## Ground Water Consultants, LLC

May 21, 2019

Re: Review of Aquifer Impact Assessment for Wickson Creek Special Utility District Proposed Well 8, Brazos County, Texas

Figure 2 Existing Wells Within 1-mile of Proposed Well #8

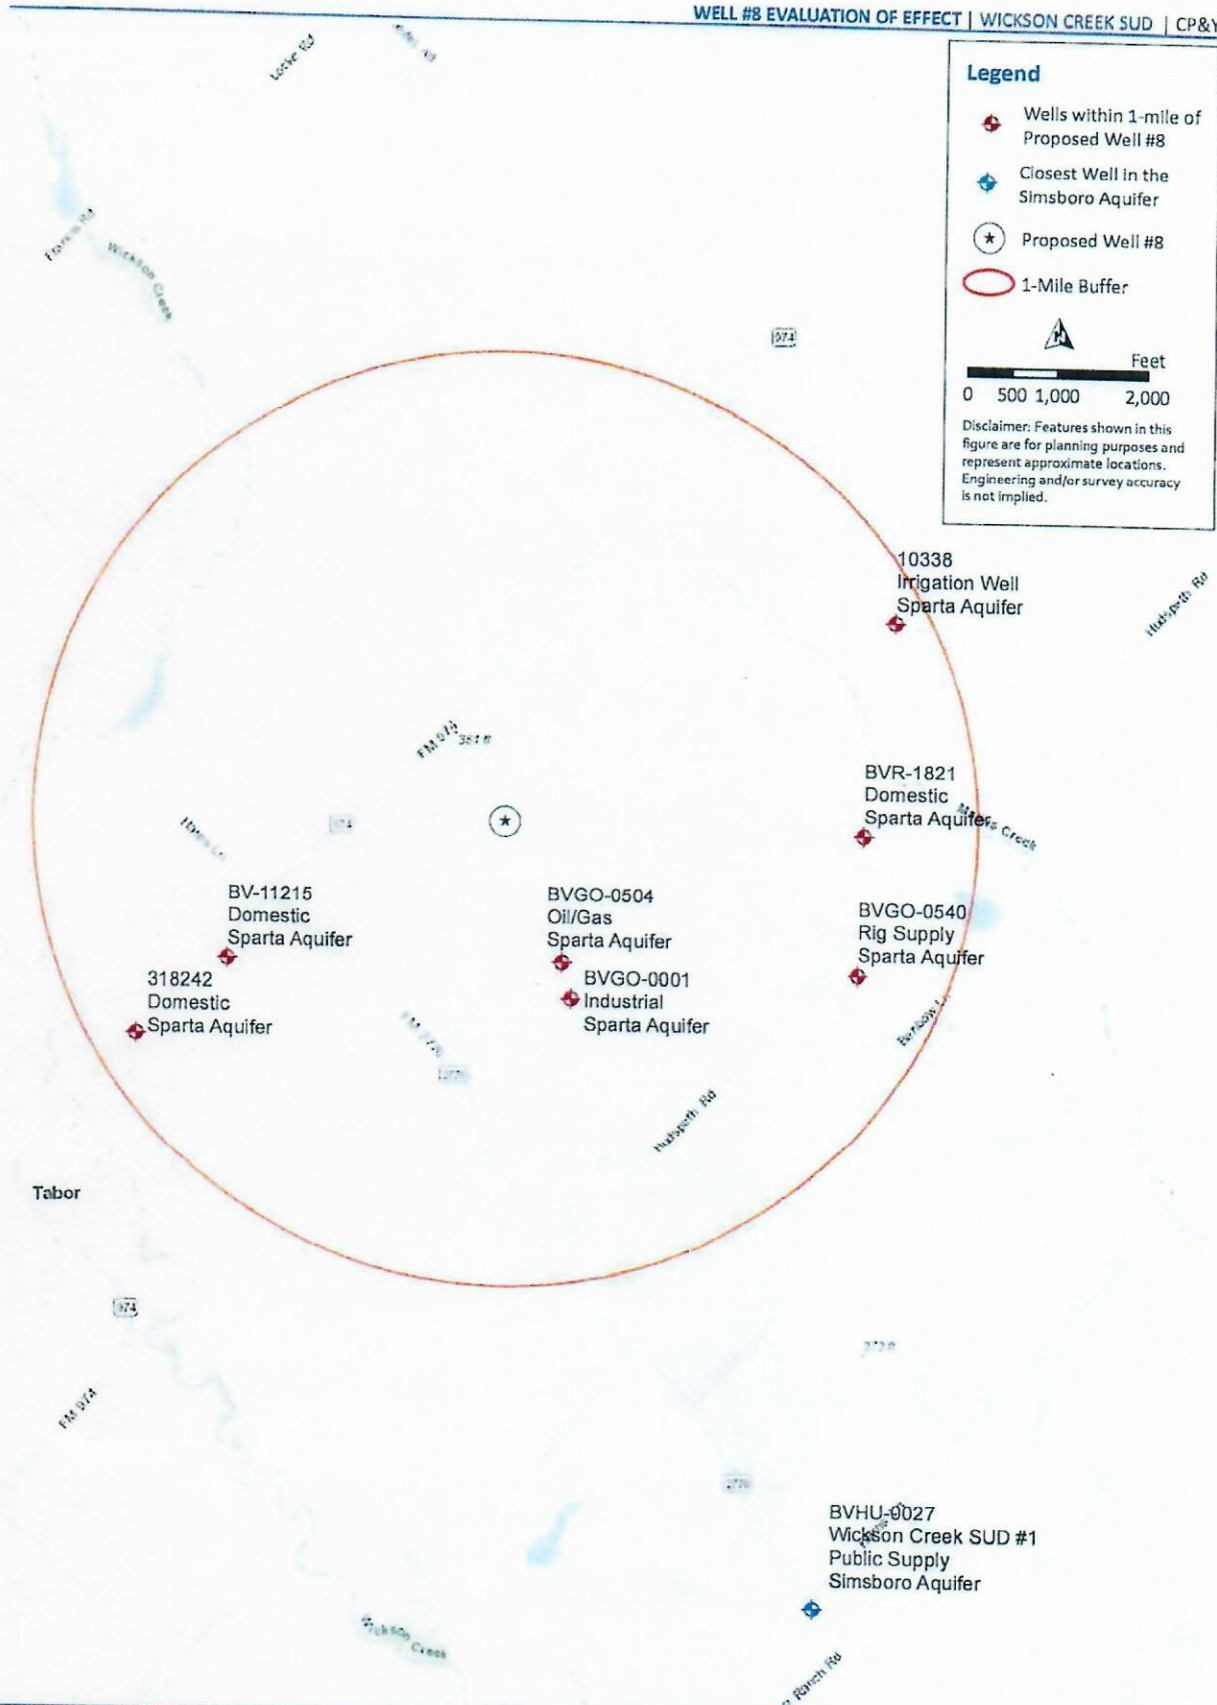
2. As required by Rule 8.4(b)(7)(B)(2), Table 2 and Figure 2 are provided in the report for wells that are located within one mile of the proposed well location and the wells screen sands of the Sparta Aquifer and not the Simsboro Aquifer. A copy of the well location map is attached that was included in the report. As required by Rule 8.4(b)(7)(B)(3), the report includes estimates of the interference drawdown that could be caused by pumping the well at an average rate of 1,144 gpm continuously for one year and ten years. The estimates of interference drawdown show that at a distance of five miles from the well the drawdown is about 10 feet or less after 10 years of pumping. The interference drawdown estimates were developed using the recently updated Queen City/Sparta Groundwater Availability Model (GAM) prepared by the Texas Water Development Board(TWDB).

The actual amount of interference drawdown that will occur with the pumping should be monitored using data from the District's water-level monitoring program.

Wickson Well Estimated Drawdown Map  
 10 Years of Pumping at 1,848 AFY  
 CWQCSP Central GAM

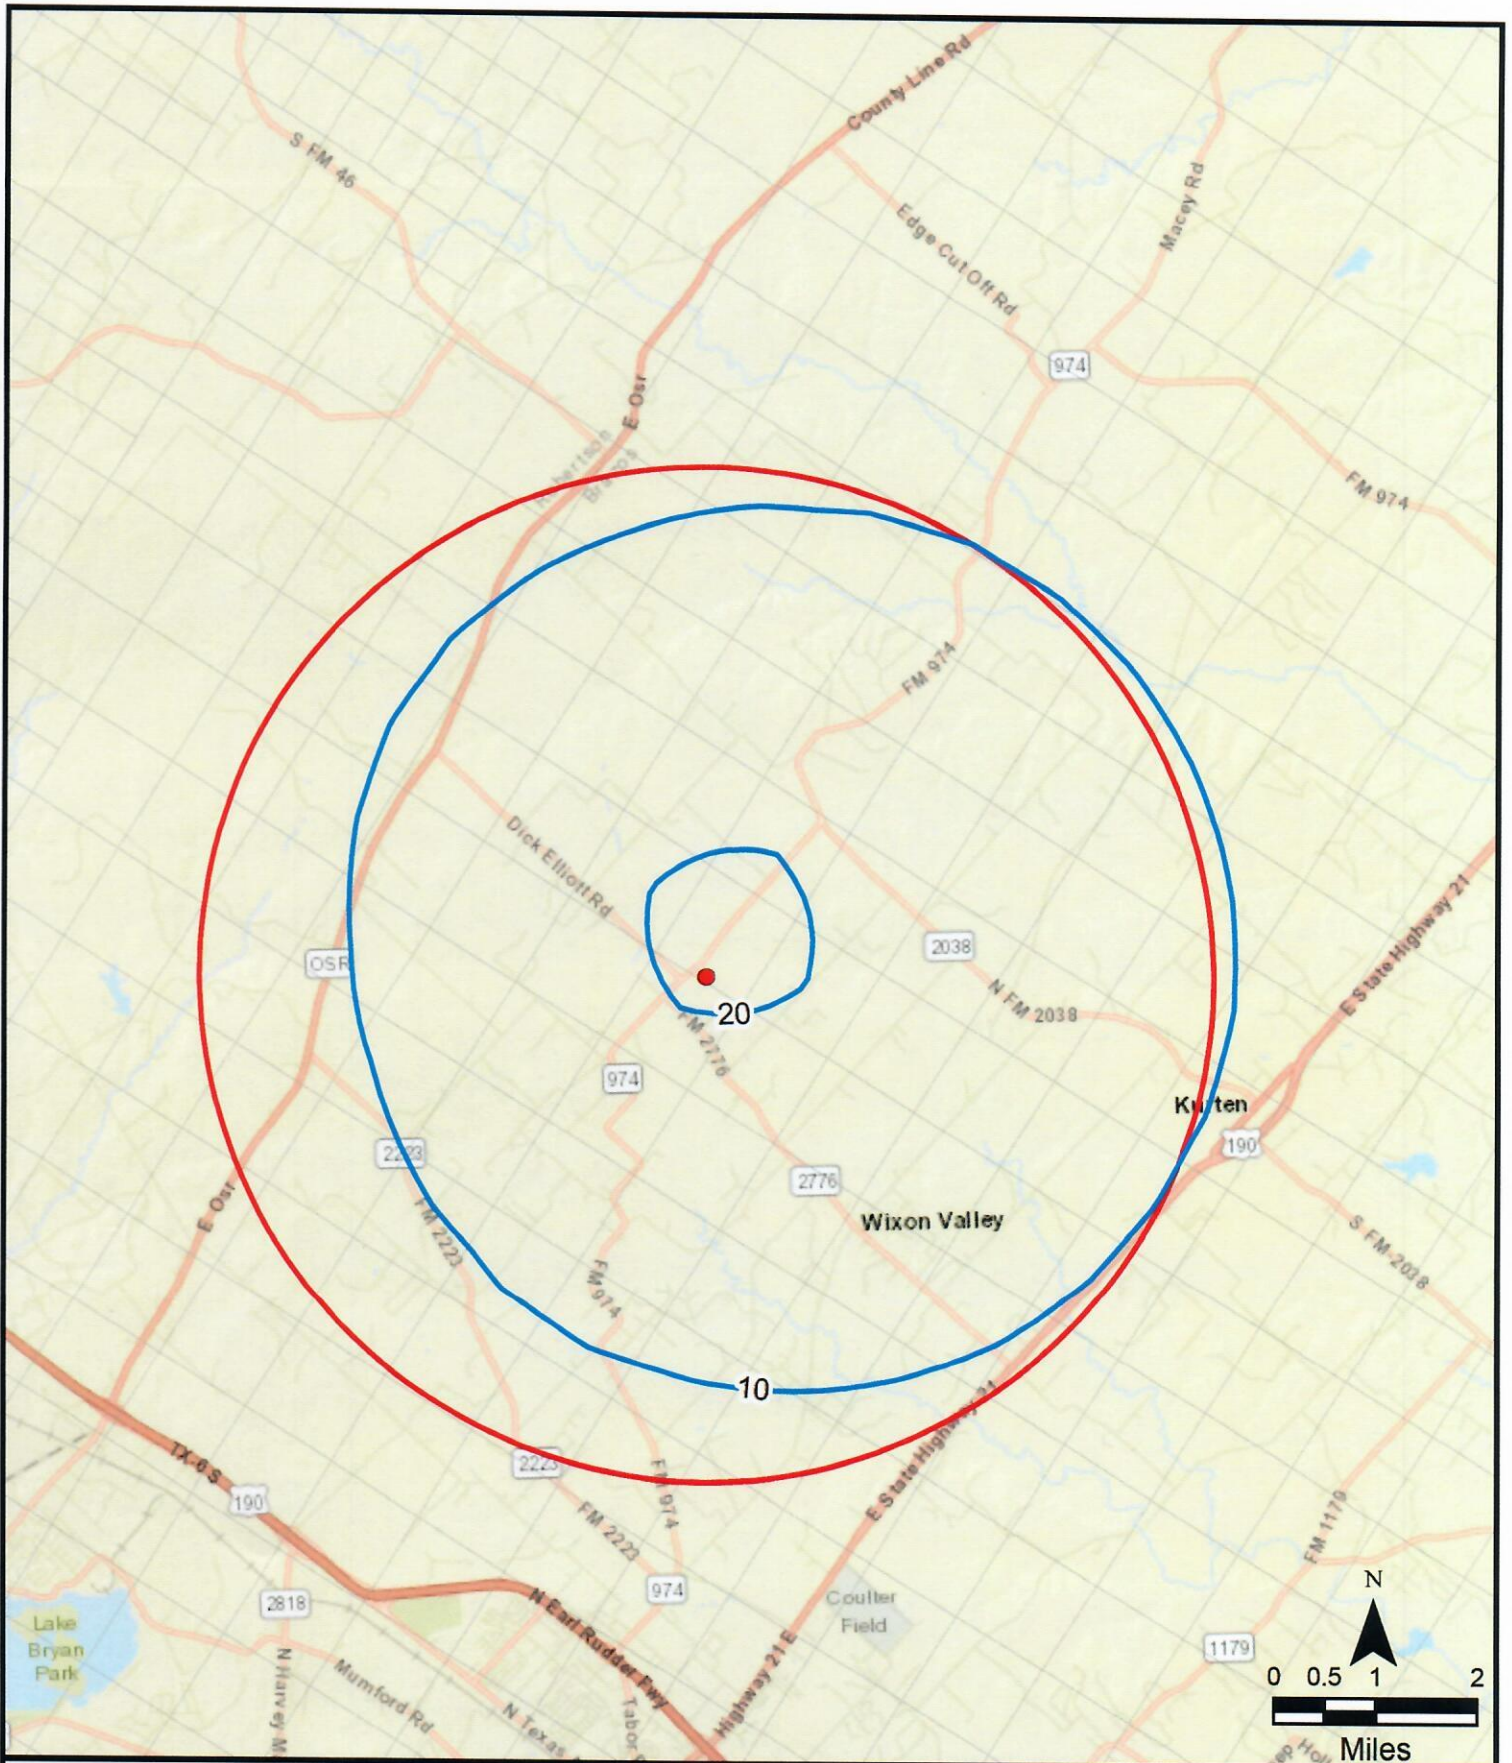
3. Ground Water Consultants, LLC(GWC) performed a model simulation with the recently updated Queen City/Sparta GAM using the same amounts of pumping in the same location as in the permit application for the same duration as simulated by Carollo and obtained results that were very similar to the results presented by Carollo. One figure showing the results of the simulation performed by GWC is attached. GWC reserves the right to perform additional model simulations in the future, if needed, and review the results.
4. The evaluation report, in general, addresses the requirements of Rule 8.4(b)(7)(B).
